**CITY OF BOULDER**  
**PLANNING BOARD AGENDA ITEM**  
**MEETING DATE: Aug. 18, 2016**

**AGENDA TITLE:** CONCEPT PLAN & REVIEW - Redevelopment of the existing seven-acre apartment site located at 1550 Eisenhower Drive with a new three-story apartment complex Eastpointe Apartment Homes, consisting of 236 proposed units in five buildings with below grade parking and on-site recreational amenities under case review no. LUR2016-00043.

**SUMMARY:** CONCEPT PLAN & REVIEW – Proposal for five new three-story apartment buildings, a fitness building and associated site amenities with below grade parking. A total of 236 apartment units are proposed where 140 units exist today.

# Diagram #1b - Site Plan Development

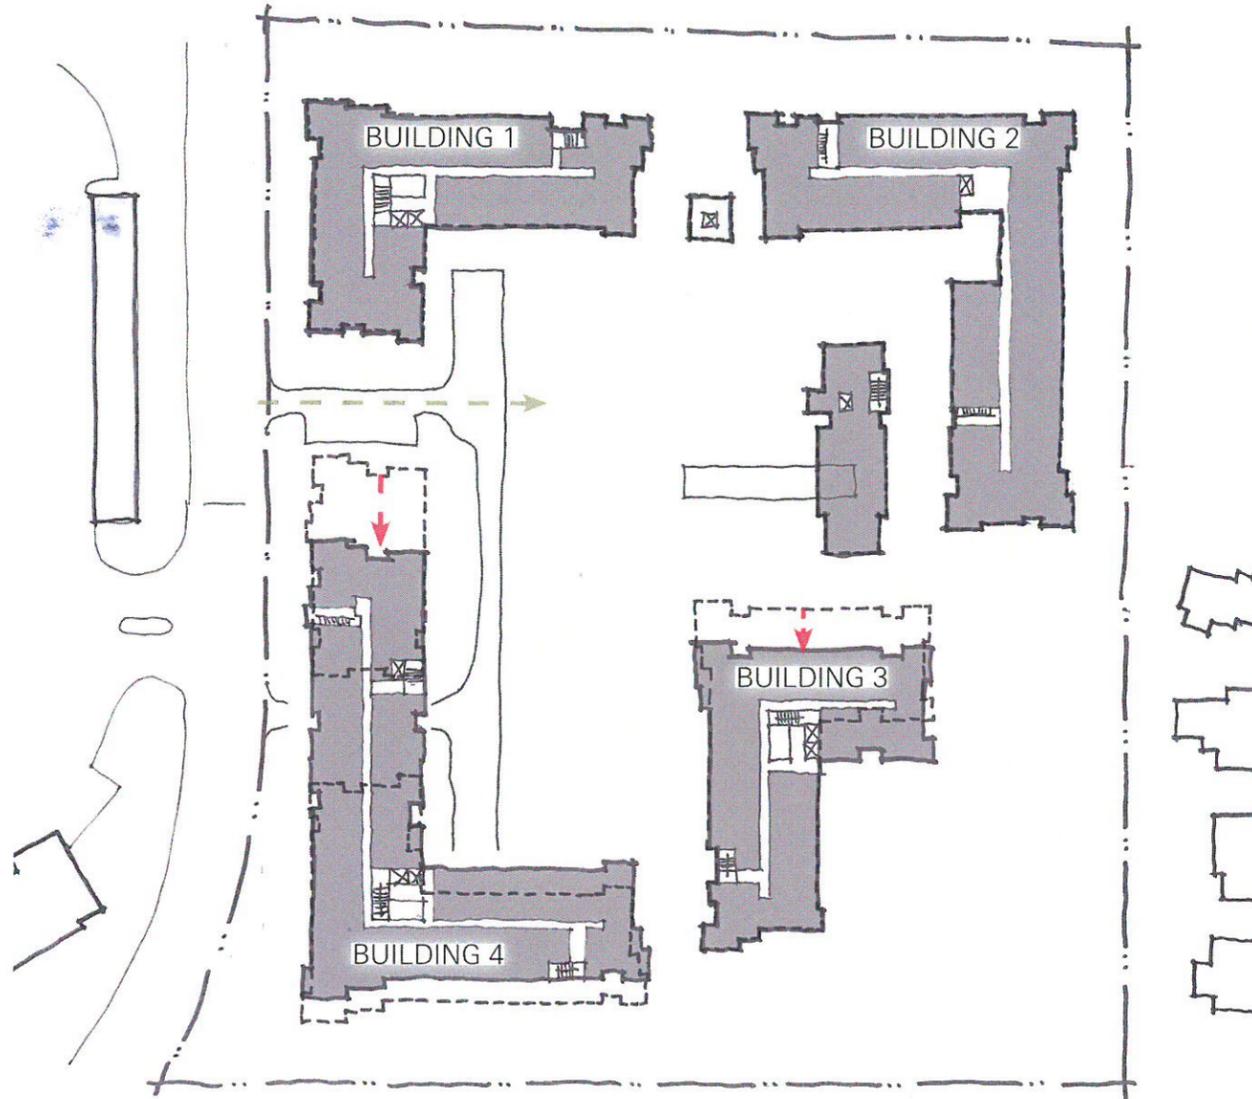
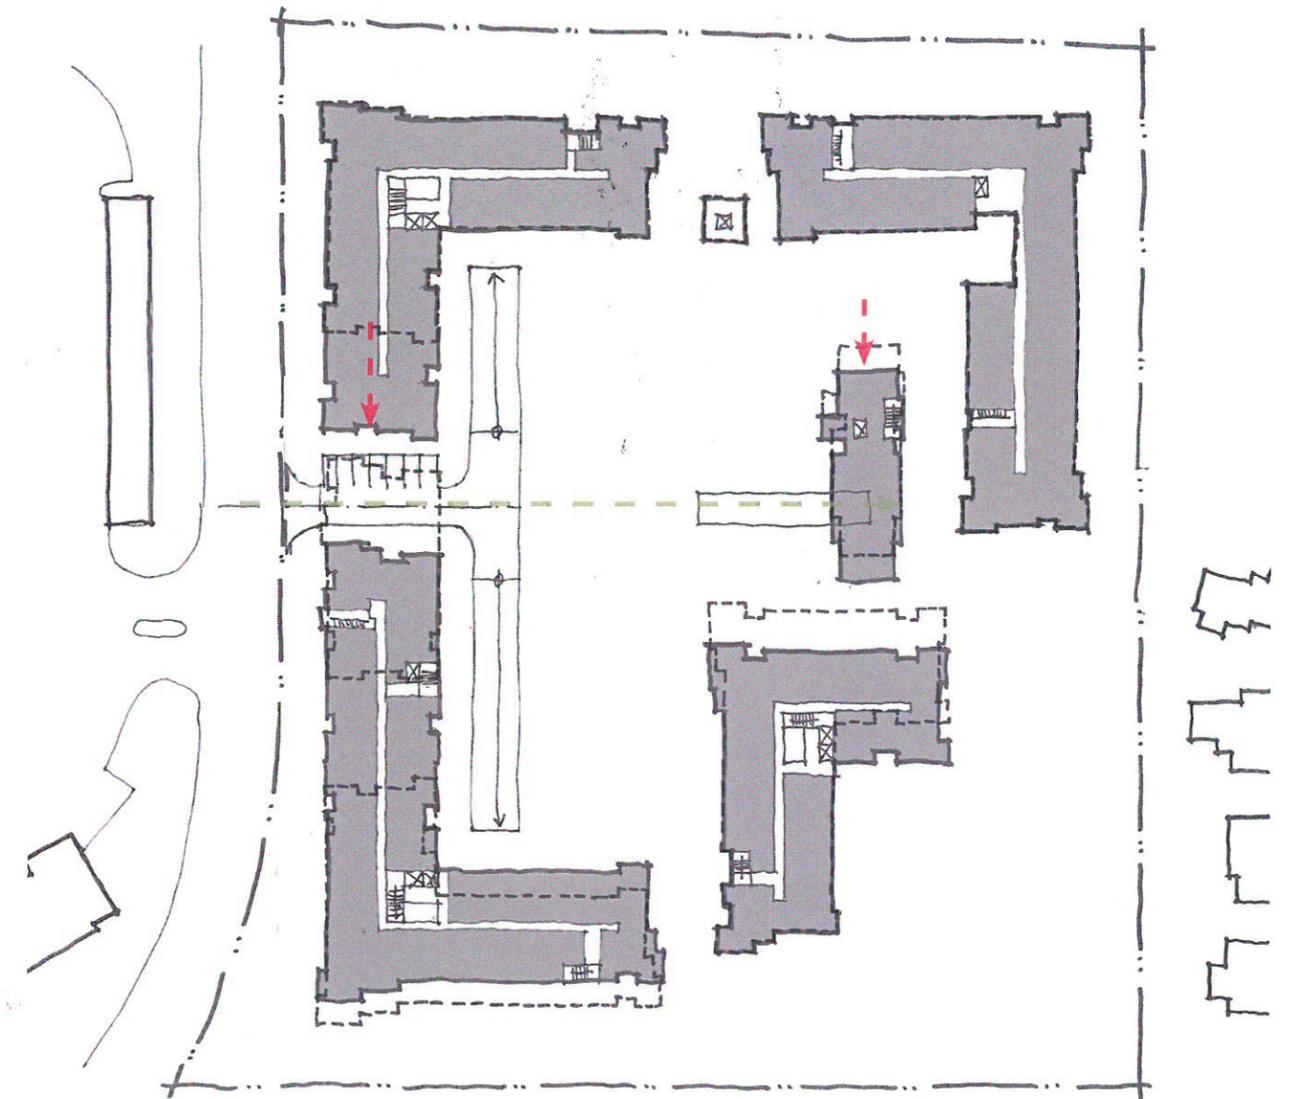
- MERGE BUILDINGS 4 AND 5 TO ALLOW FOR SINGLE ACCESS POINT
